Ref: 24043
26 August, 2026

NZSki Limited

RE: e3s 24043 –Remarkables Upgrade and Doolans Expansion TEcIA Stakeholder Response (ORC)

1 Purpose

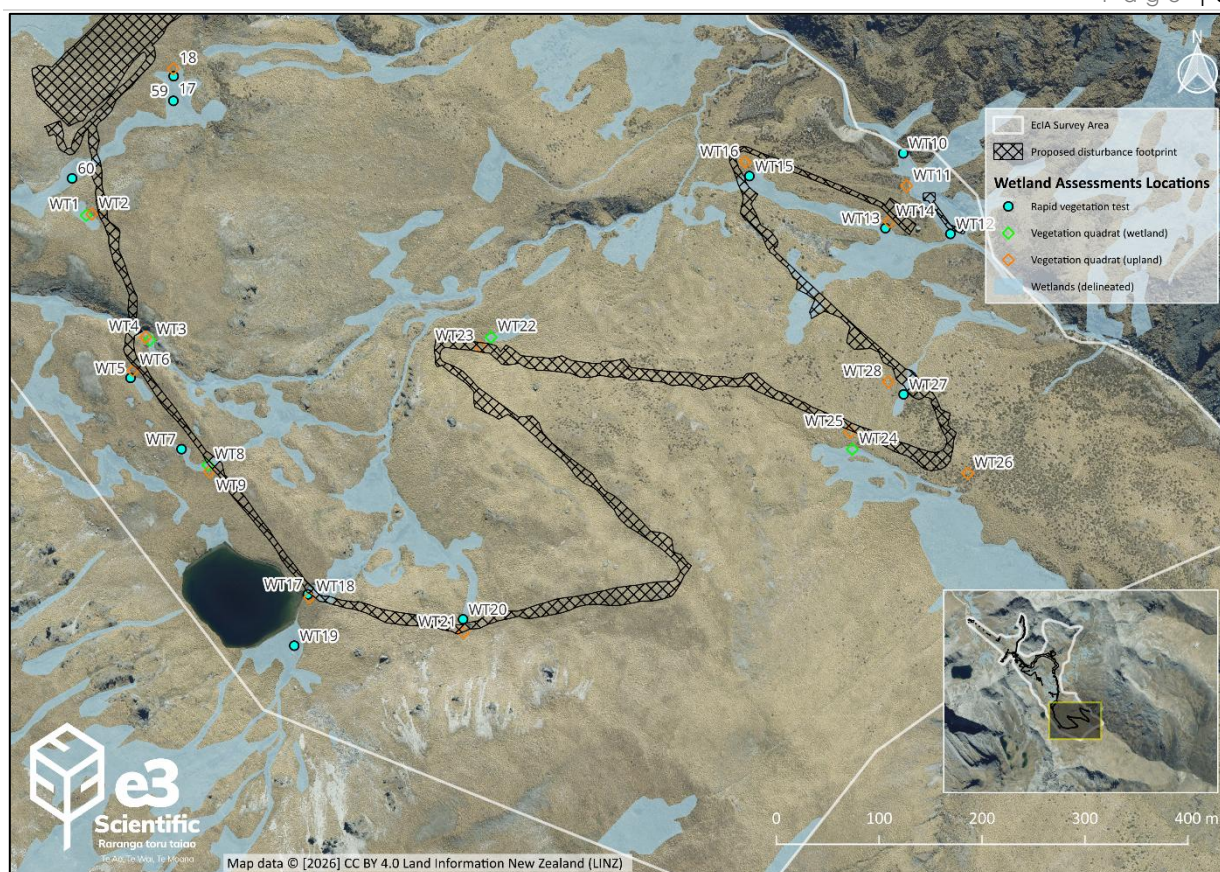
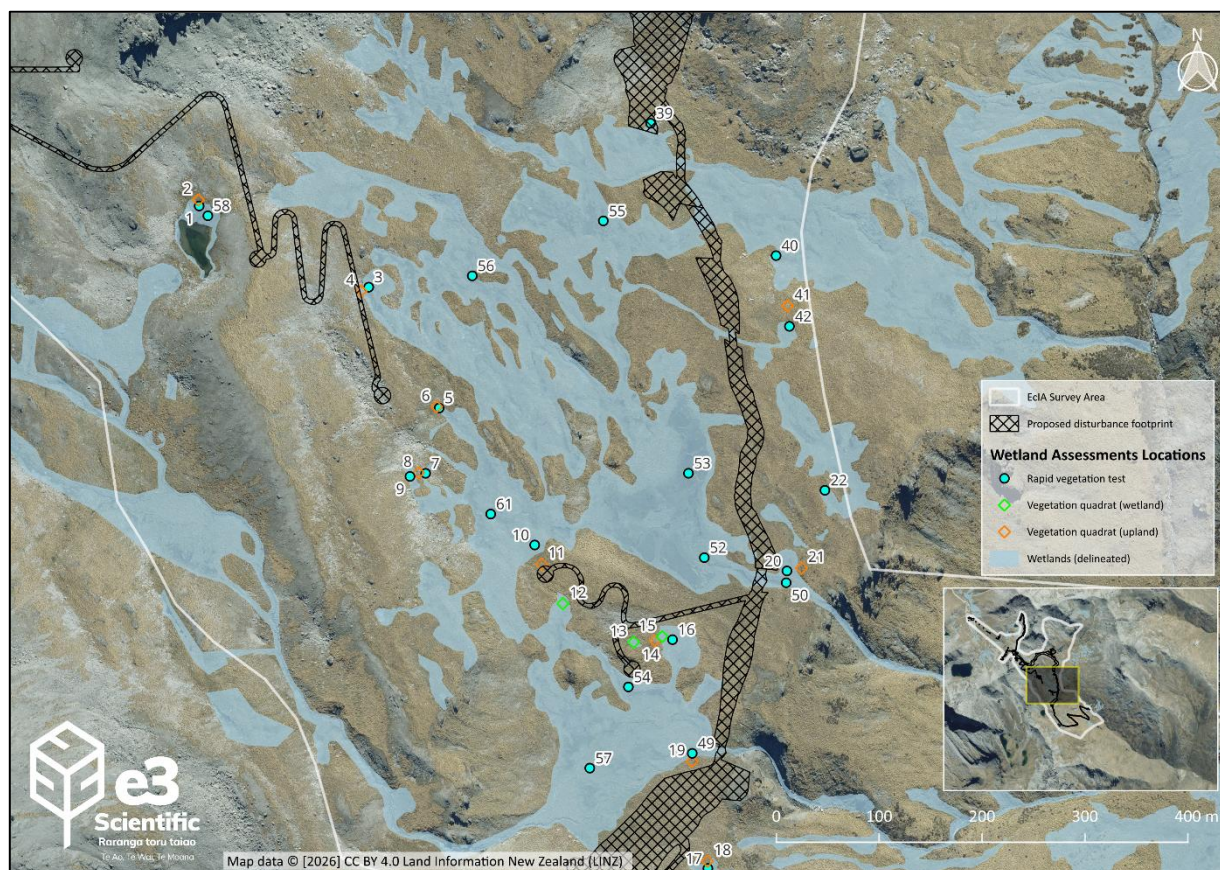
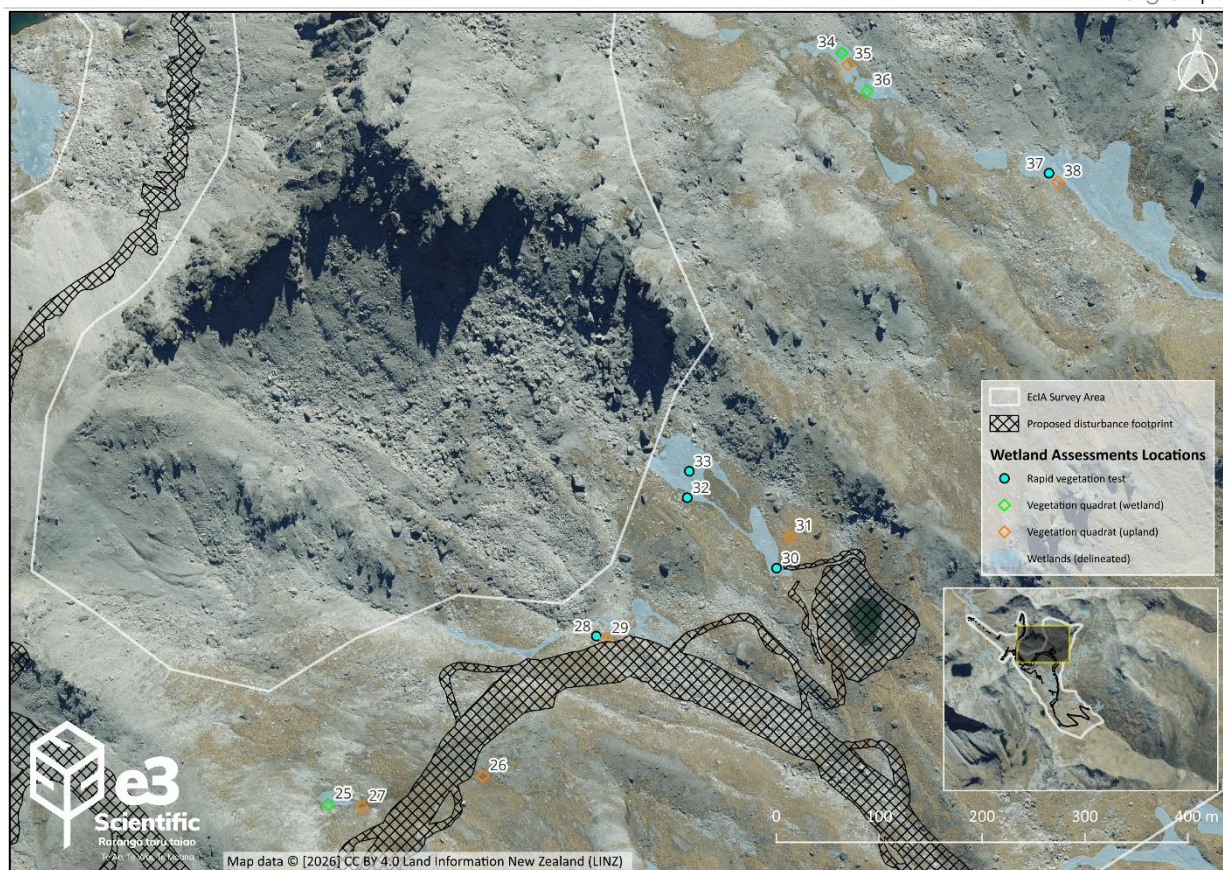
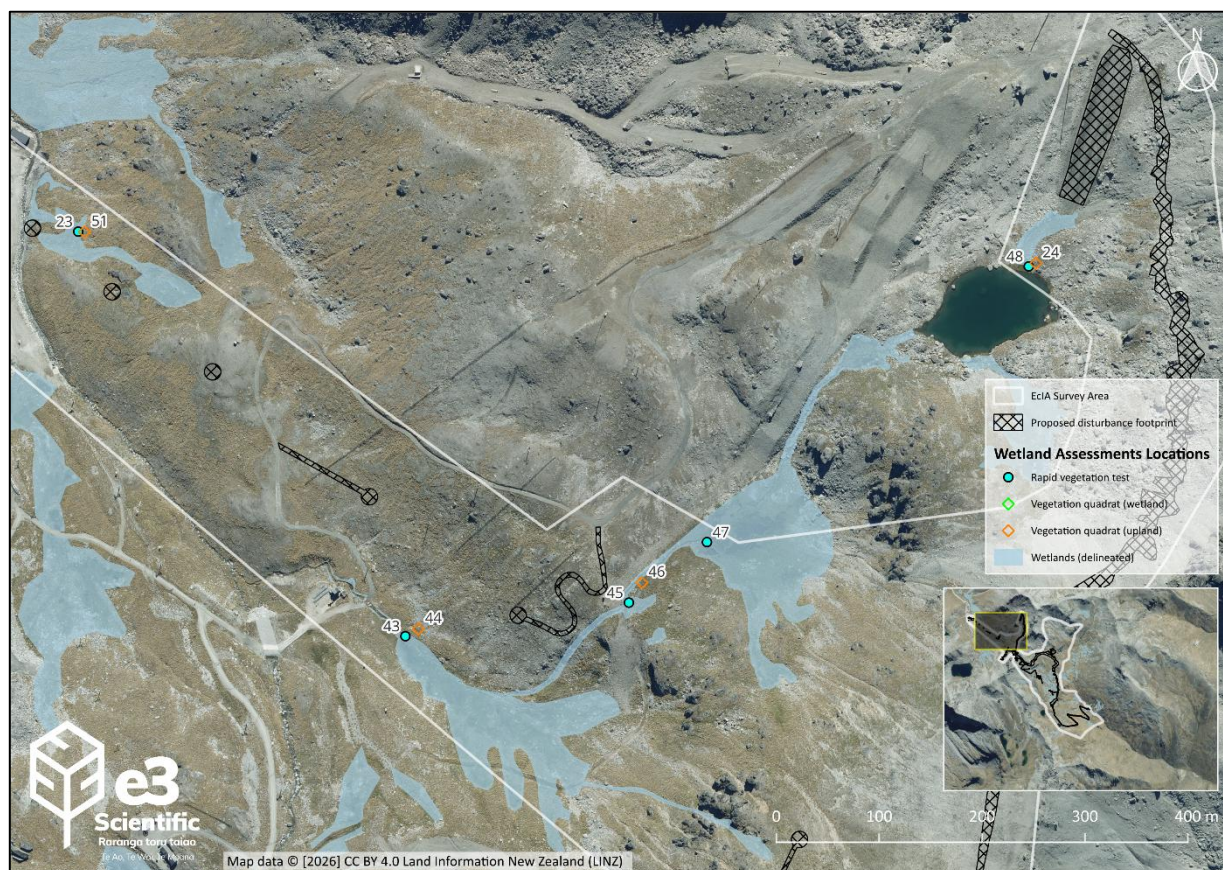
Figure 20 (EcIA) shows wetlands and wetland assessment locations. The scale and symbology makes it difficult to assess. It would also be useful to overlay the proposed works on this map (although it is done in Figure 26, this is also difficult to assess).

e3s response – Additional larger scale figures have been produced below for ease of interpretation (see Figure 1 – Figure 4).

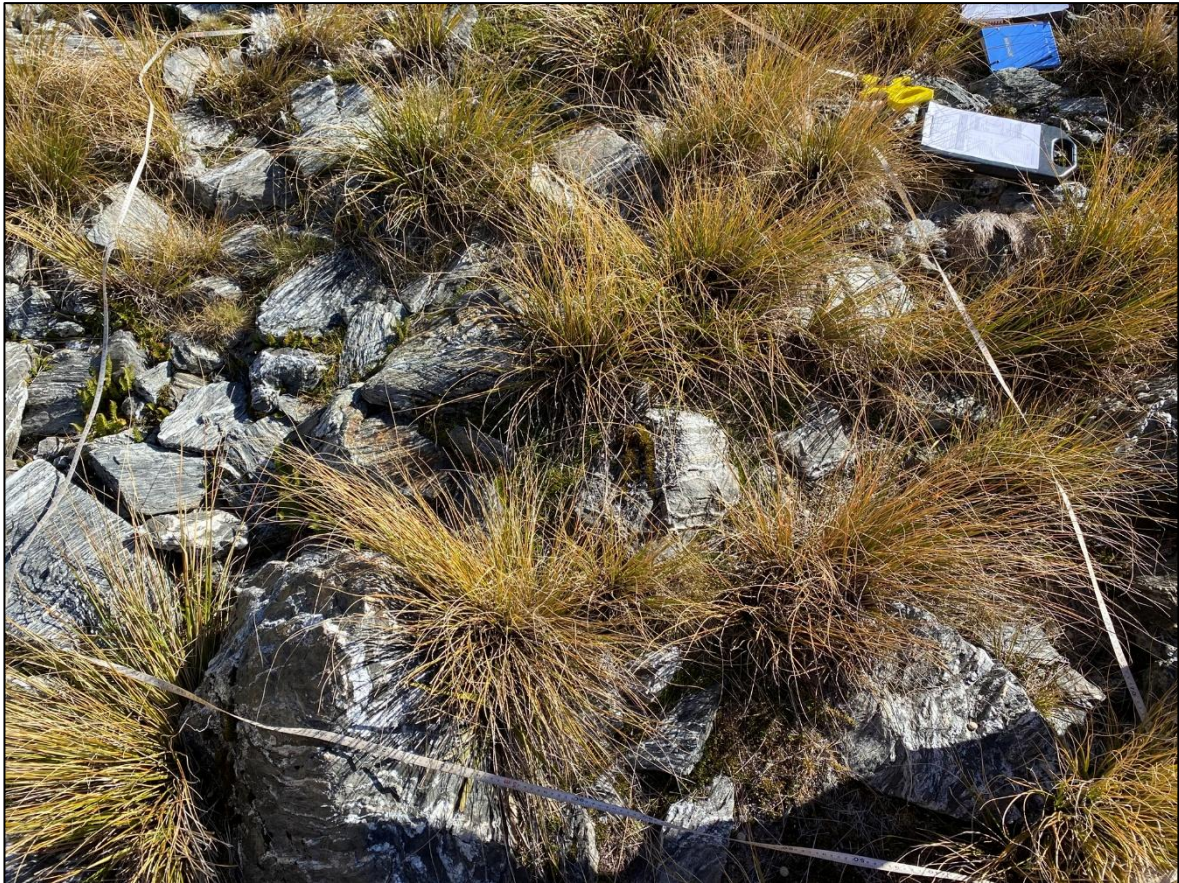
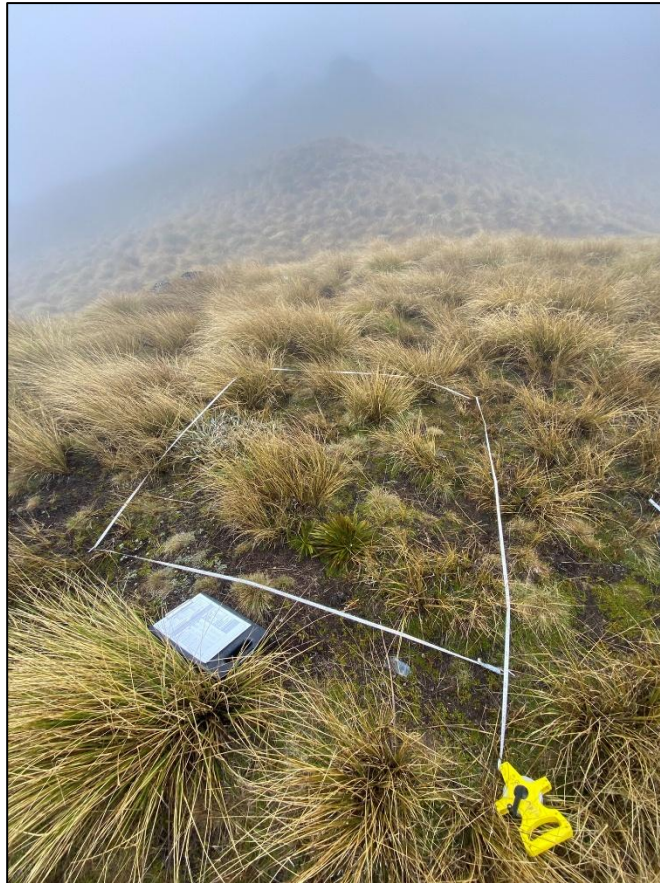
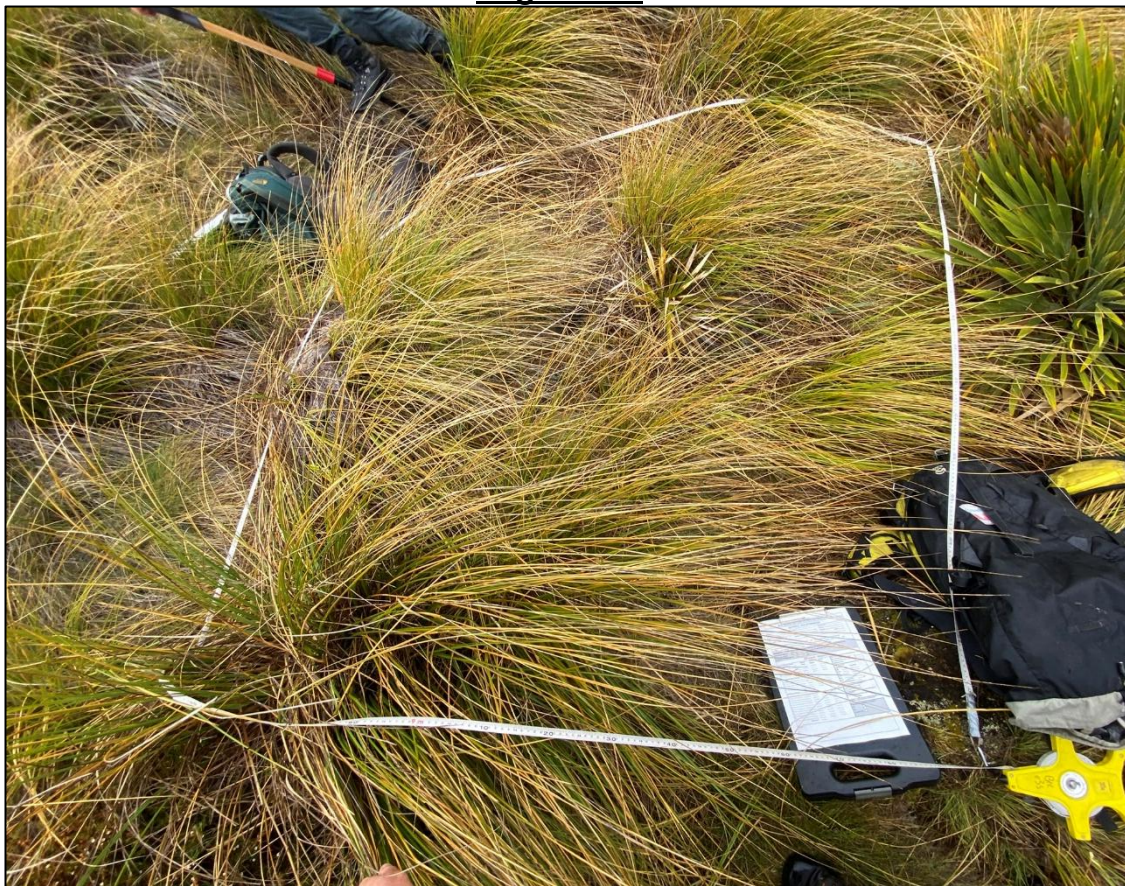
There are field datasheets for the assessments, however there are no photographs to support findings, particularly useful for instances where soil colour is in the low chroma group, but has been determined non wetland.

During my site visit, the wetland cores taken were all of peat-based wetlands. The applicant ecologist commented on lack of mottles, however, these are unlikely to be found in peat. Photographs would assist in ensuring wetland soil identification had been undertaken accurately.

e3s response – Please refer to Attachment 1 of this memo for quadrat photographs.

e3s response – The peat wetlands within the study area are underlain by mineral-derived sediments, deposited through glaciation and subsequent natural erosion; common within the alpine-subalpine zone of the Southern Alps. Many of the soil profiles exhibit reduced conditions and redoximorphic features (occasionally presenting as mottling) within the mineral B-horizon, reflecting prolonged seasonal saturation, as shown in Table 4 of the TEcIA. Please refer to Attachment 1 of this document for quadrat photographs.
